Point Beach Nuclear Plant Unit 2
Docket 50-301
License No. DPR 27

Response to Request for Additional Information Regarding
Request for Exigent Review of Heavy Load Analysis

RESPONSE TO REQUEST FOR ADDITIONAL INFORMATION REGARDING REQUEST FOR REVIEW OF HEAVY LOAD ANALYSIS

**DIAGRAMS OF WATER FLOWPATHS
FROM THE TEMPORARY CONNECTIONS TO THE REACTOR CORE**

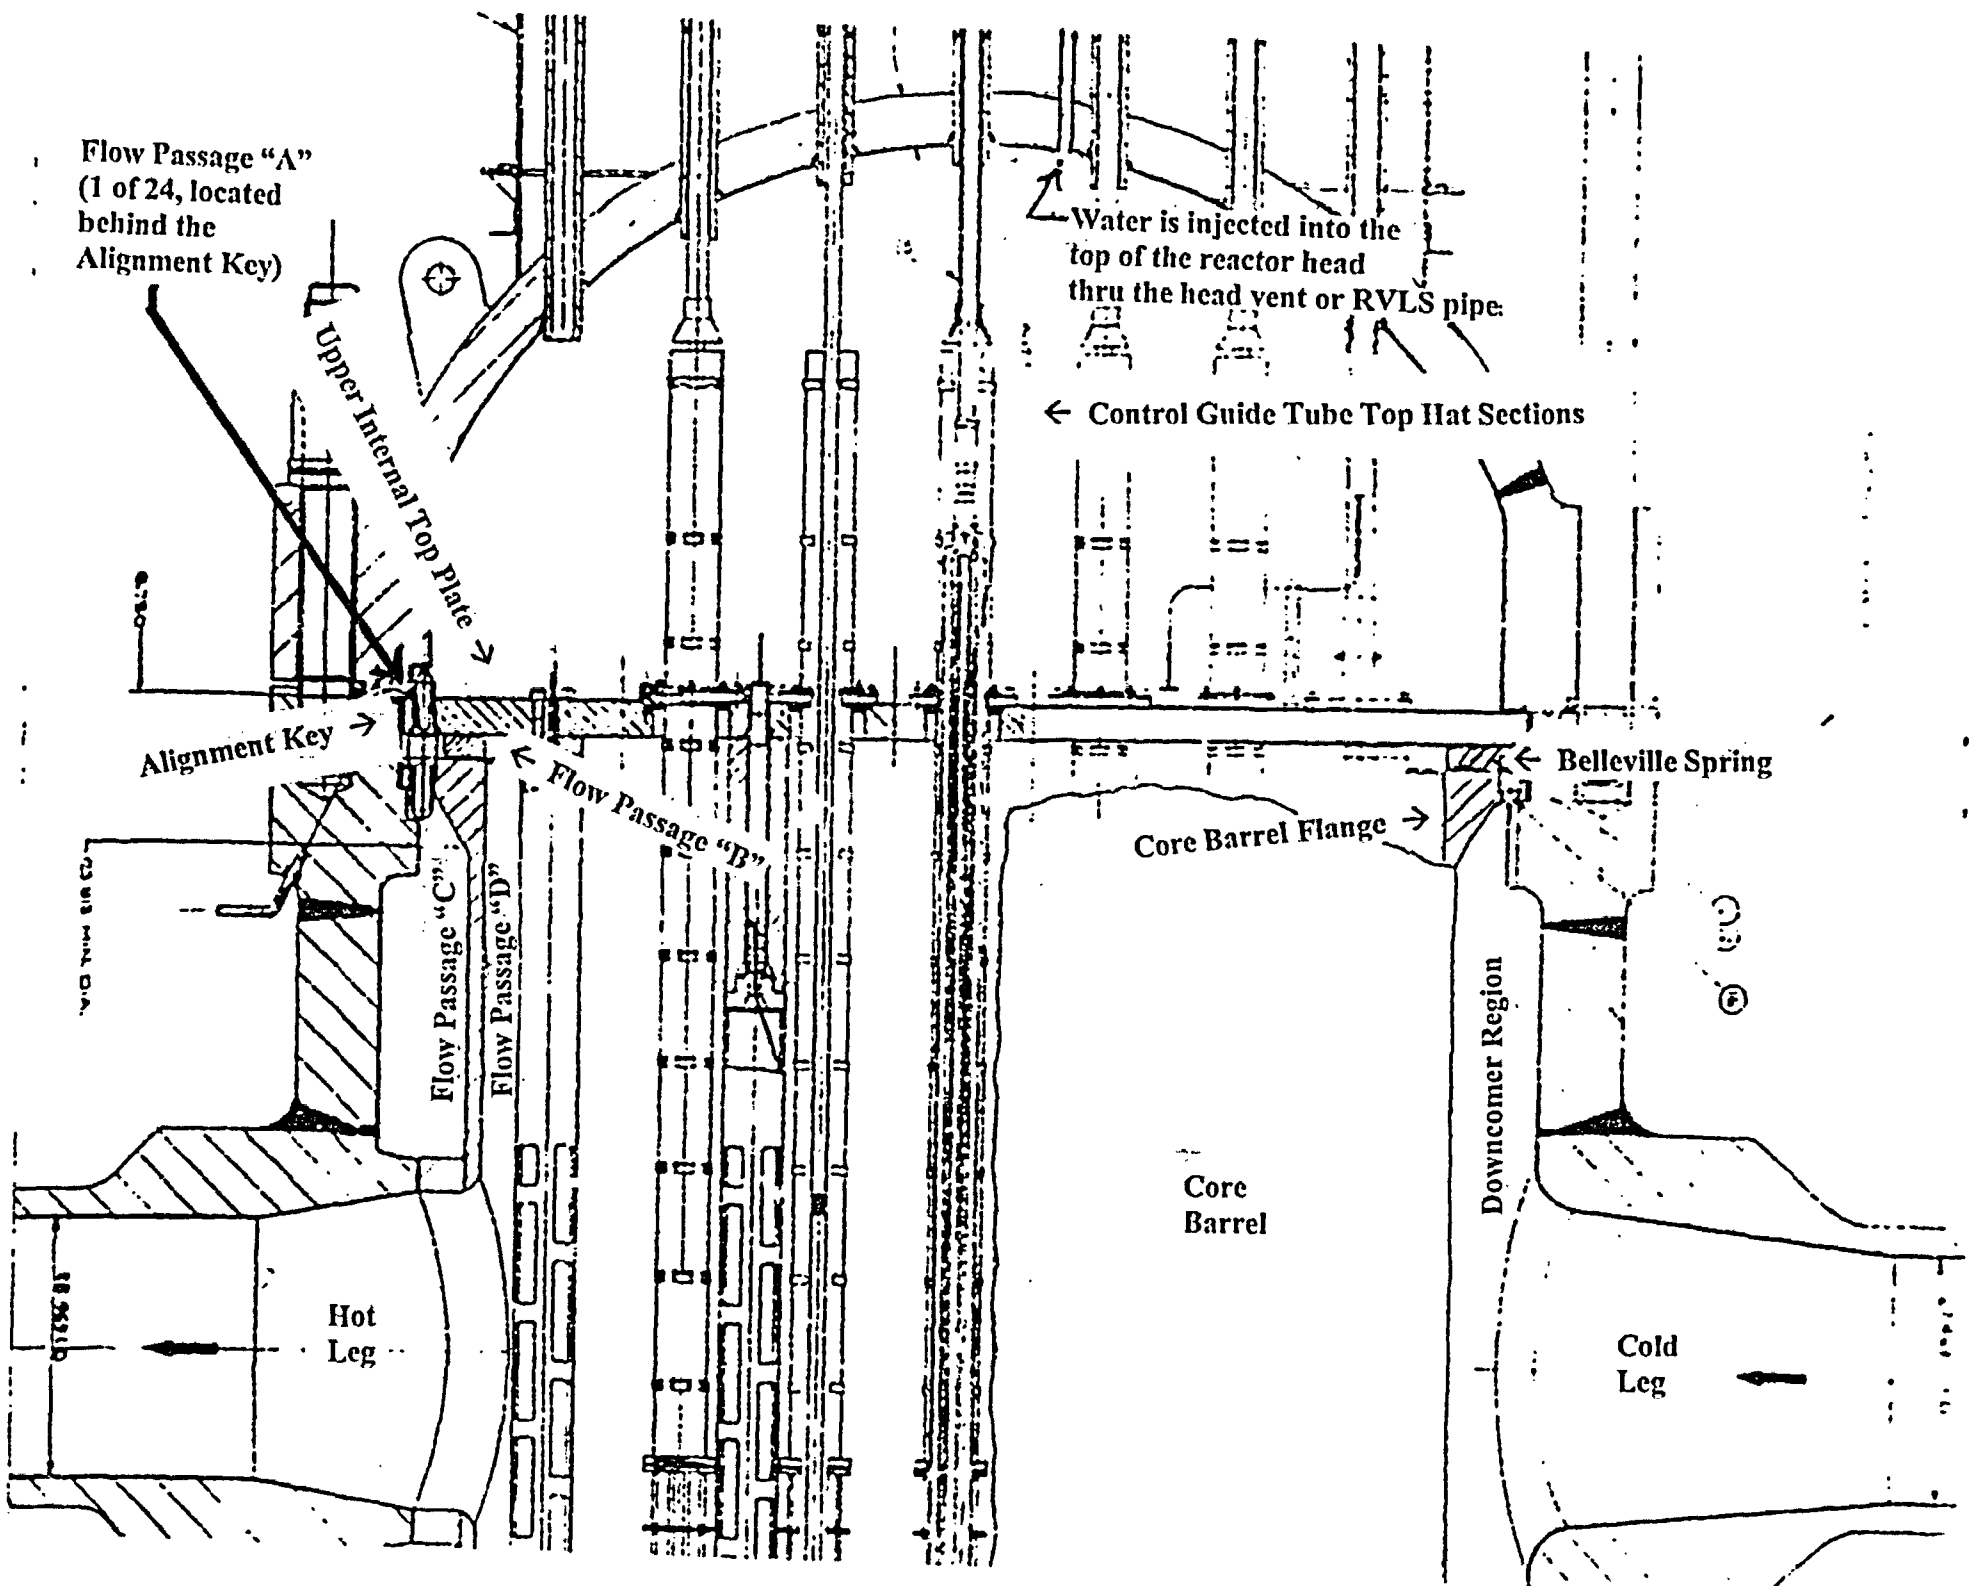
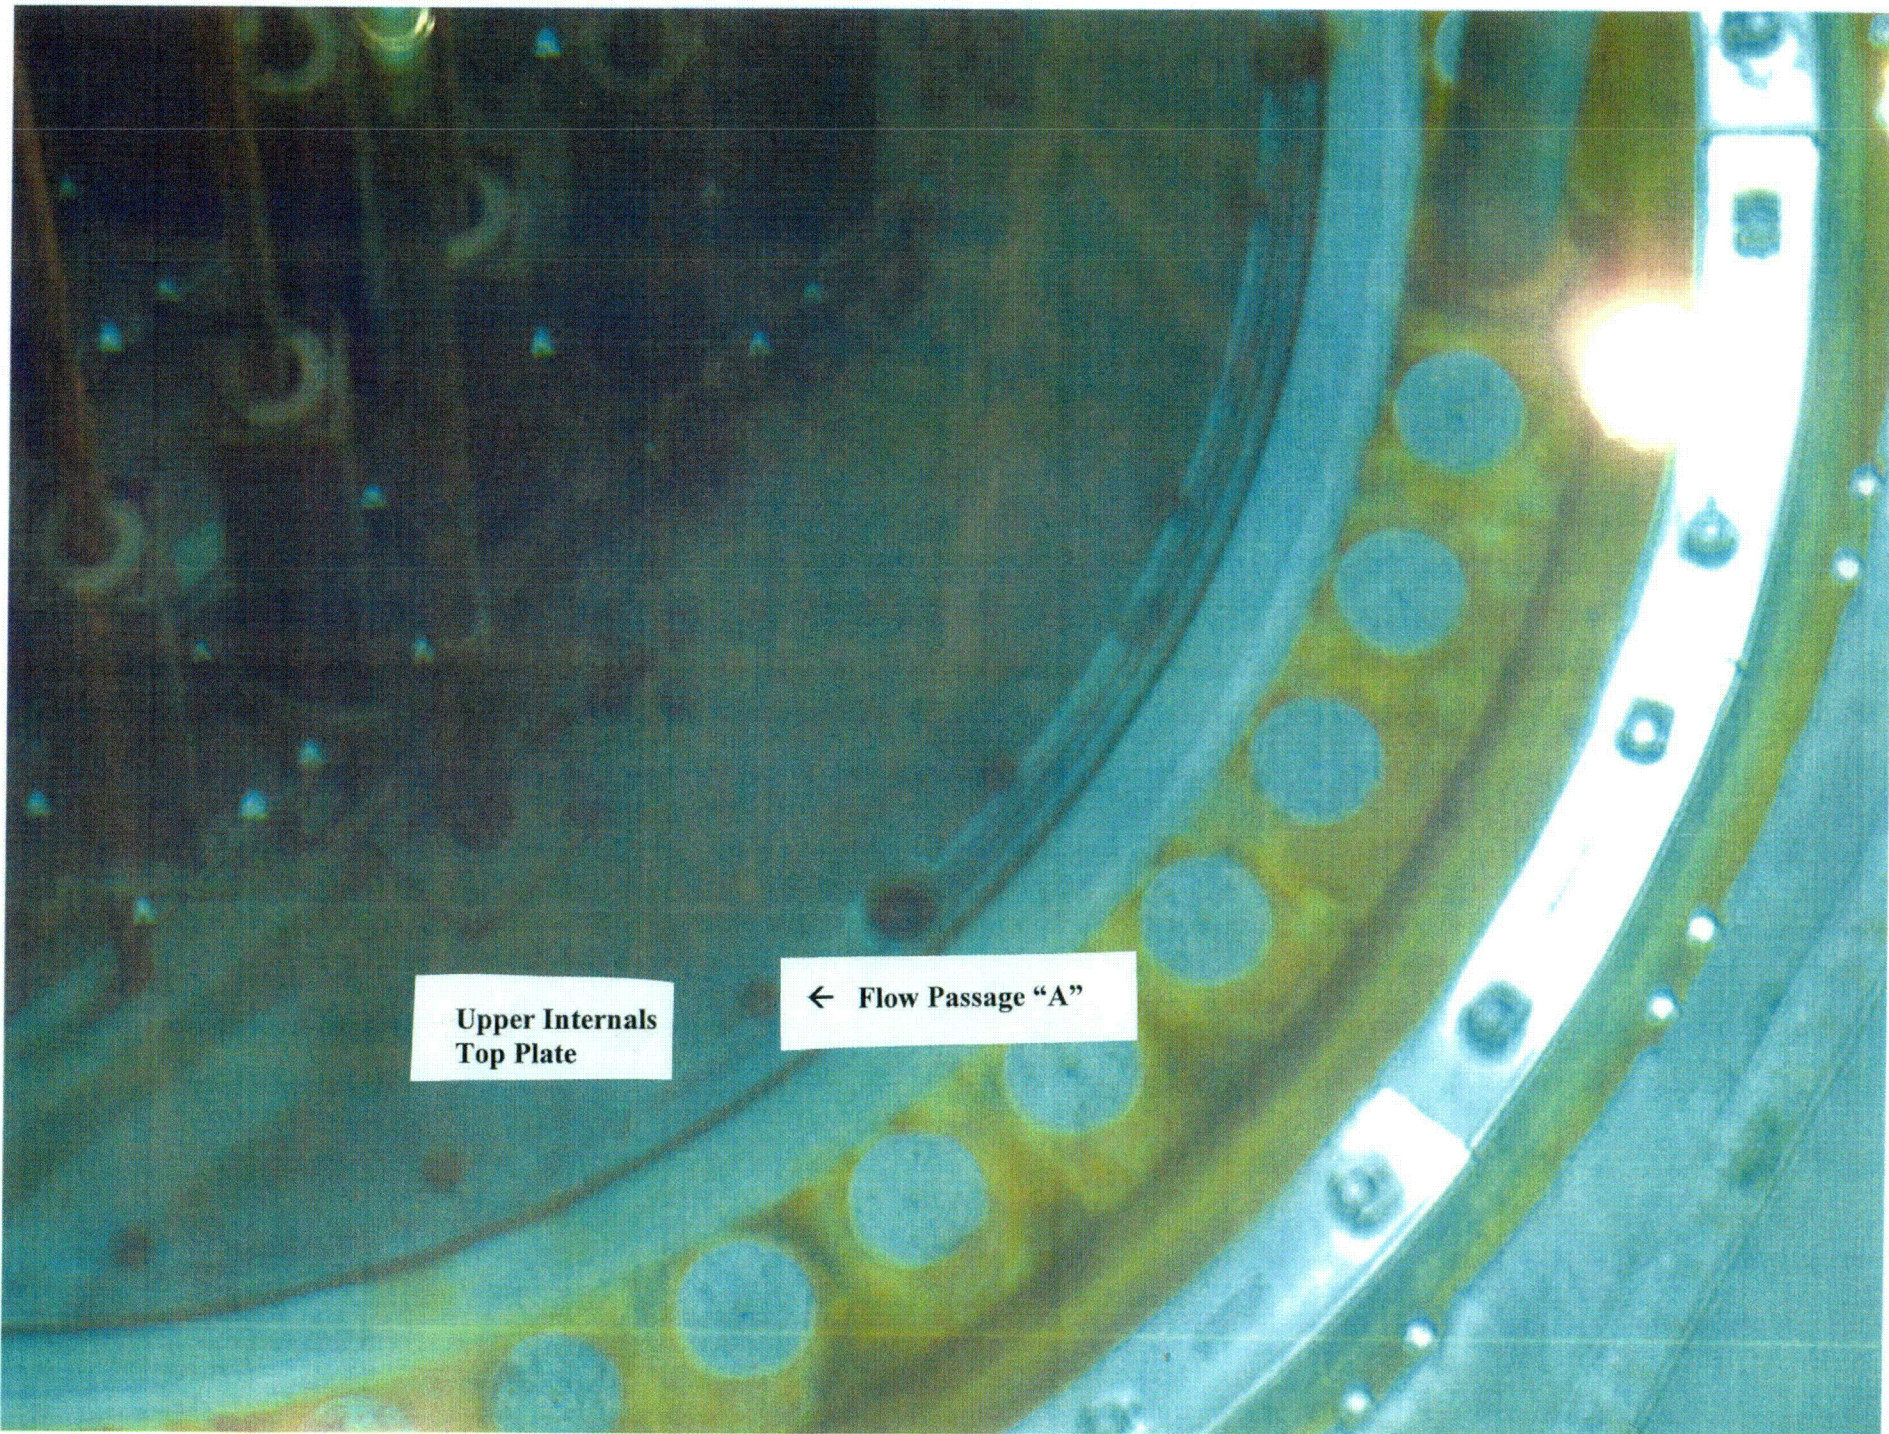
Provide an evaluation establishing that splashing of water injected through the proposed temporary connections to the upper head will not result in loss of water. Stated differently, all water entering via the upper head must be shown to flow into the downcomer or the upper plenum below the elevation of the reactor vessel flange.

Show that there is a lip of sufficient height on the top plate structure to trap injected water and reasonably ensure the water will flow into the downcomer or into the upper plenum below the elevation of the reactor vessel flange. If such a lip does not exist, then establish that a configuration exists that reasonably ensures water will flow into the downcomer or into the upper plenum below the elevation of the reactor vessel flange. A cut-away view of the hardware is necessary that clearly shows the configuration and the passages where water will flow downward.

Enclosure 2 provides clarifying diagrams of the expected flowpath of water from the connections of Temporary Modification (TM 2005-008) to the reactor core. The annotations of A, B, C and D refer to the diagrams in Enclosure 2.

Once flow is initiated, water will enter through the top of the head near the center of the dome. Gravity will direct this flow downward towards the upper internals top plate. The upper internals top plate is a flat plate with 33 control rod guide tube top hat sections extending above the top of the plate. Splashing as a result of the relatively low entrance velocity would be captured under the dome of the head and flow down along the inside surface to the periphery interface between the head and the upper internals top plate. The control rod guide tube top hat sections would also serve to dissipate entrance velocity and splashing before the water gets to the periphery. The mating surface between the head and the top of the upper internals top plate prevents water from escaping the head region.

The holes in the upper internals (A) and the head cooling spray nozzles (B) in the core barrel communicate directly with the down comer region of the core barrel (C). These

holes are equally spaced about the periphery of the upper internals and core barrel. The core barrel and hot legs are fit to prevent communication from the hot leg to the downcomer region. During use of TM 2005-008, there is no water pressure to cause flow upwards into the hot leg and the hot leg is tapered towards the vessel. The taper, with the aid of gravity, will direct any leak back into the upper plenum. Therefore, the hot leg is not a path for injected water to escape. The cold leg nozzles represent approximately 13% of the perimeter and the holes (A) are equally spaced about the vessel. It is not expected that splashing would result in water loss out of this 13% of the periphery. Gravity will direct the water into the down comer at a zero degree angle from vertical in a steady stream. There are no internal structures in this region of the core barrel that would deflect water out of the cold leg. The vessel is a minimum of 9 inches thick at the cold legs, which would require the stream at an angle of deflection greater than 12° to reach the outside of the vessel. The cold leg nozzles are tapered toward the vessel, which, with the aid of gravity, would return any misdirected water back toward the downcomer. It is therefore expected that no water would splash out of the cold leg nozzle.

Water entering via the upper head will flow into the downcomer through 24 nozzle openings in the upper internals top plate. These openings are slightly below the top surface of the upper internal top plate. The mating surface between the head and the top of the upper internals top plate keeps the water from escaping the head region. The core barrel and hot legs are fit such that leakage between the downcomer and the nozzle will be minimal. The internal taper (toward the vessel) of the hot leg nozzle will return any leakage back to the upper plenum via gravity.

Enclosure 2 provides clarifying diagrams of the expected flowpath of water from the temporary connections to the reactor core. The annotations of A, B, C and D refer to the diagrams in Enclosure 2.

The head drop analysis considers a concentric drop that results in the head resting on the upper internals top plate. The head is expected to be directed to this position by the guide studs. The core barrel sits 6.75 inches under the vessel flange. The head will rest on the upper internals top plate. The upper internals are held up by the fuel hold down springs. There will be metal-to-metal contact around the entire periphery of the head to

upper internals interface. There will be negligible water flow escaping from this mating surface as the pressure head above this interface is small and the less restrictive flow path is through the head cooling spray nozzles. Thus, the flow will be directed into the 24 upper internals peripheral holes (A). If the spring force of the fuel assemblies is insufficient to hold up the head, the upper internals top plate will sit on the core barrel circumferential Bellville spring and all water will be directed down the head cooling spray flow nozzles. The inlets of the spray nozzles are slightly below the top surface of the upper internal top plate, which is 0.813 inches below the reactor vessel flange. If the upper internals top plate rests above the core barrel circumferential Bellville spring due to the fuel assembly spring force, then the water can directly enter the core barrel and have direct communication with the top of the fuel assemblies (D). There will be minimal pressure drop in the flow path from A to D. The flow path from A to C results in a driving-head of approximately 1.5 inches of water to achieve a calculated total flow for all spray nozzles of 12.5 gpm.
